DOCUMENT TRANSMITTAL 2003-1134

115 - 115 - CHEMISTRY SAMPLING TEAM: EMERGENCY
PLAN-POSITION SPECIFIC PROCEDURE

PROCEDURE CHANGE PROCESS FORM

5. PROCEDURE TITLE TSC Chemistry Sampling Team Emergency Plan Position Specific Instruction				
6. REQUESTED CHANGE PERIODIC REVIEW <input checked="" type="checkbox"/> NO <input type="checkbox"/> YES INCORPORATE PCAFS <input checked="" type="checkbox"/> NO <input type="checkbox"/> YES # <u> </u> # <u> </u> # <u> </u> # <u> </u> REVISION <input type="checkbox"/> PCAF <input checked="" type="checkbox"/> DELETION <input type="checkbox"/> (CHECK ONE ONLY)

Attachment D

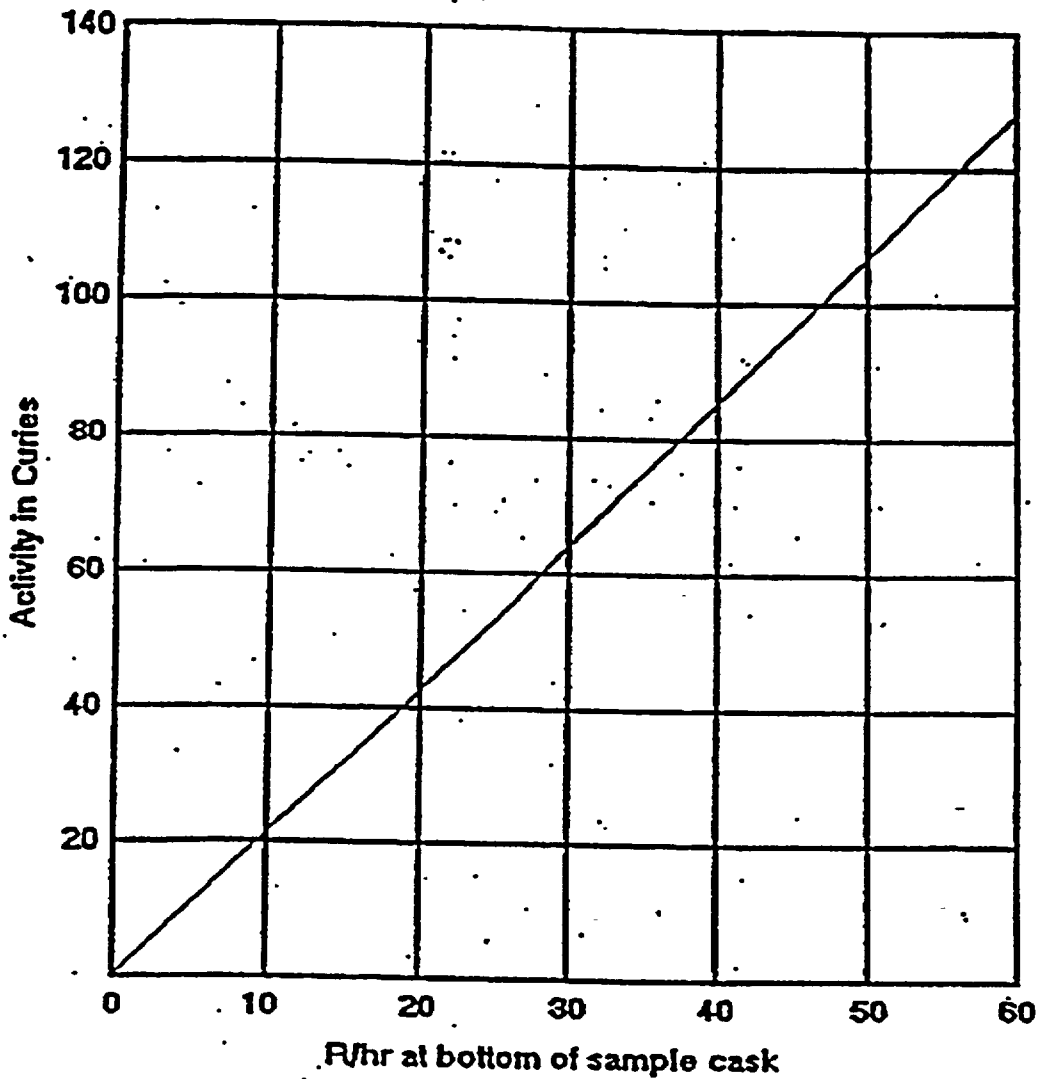
7. SUMMARY OF / REASON FOR CHANGE Added information to Attachment C, D, E, and F that was inadvertently omitted from Rev 5 when it was issued. This change is administrative and does not change any technical content. Therefore, the PCAF can be approved by the responsible supervisor.				
Continued <input type="checkbox"/>
